Product Change Notification		Date February 15, 2023
Product	Digi ConnectCore 6UL SOMs and SBCs

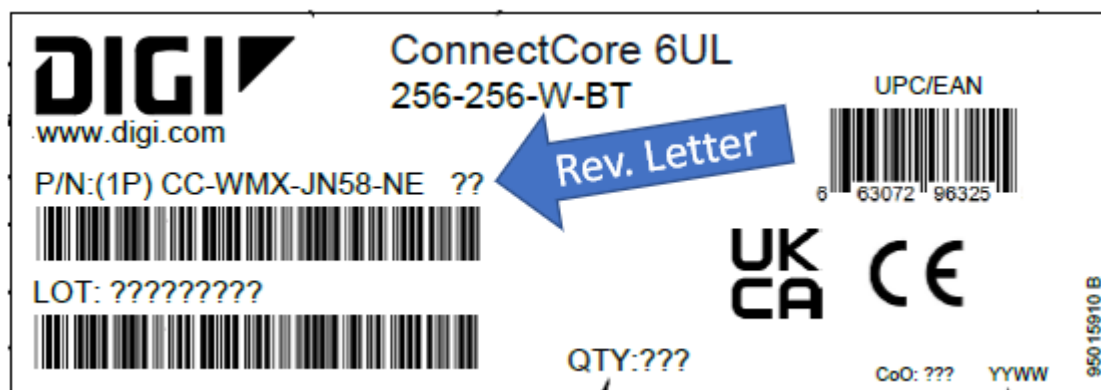
Timing of Change	Effectivity: 1 st July 2023 P/N Upper Level (Packaging label) Revision will be incremented. P/N SOM Label 5000xxxx-xx Revision will be incremented.
------------------	--
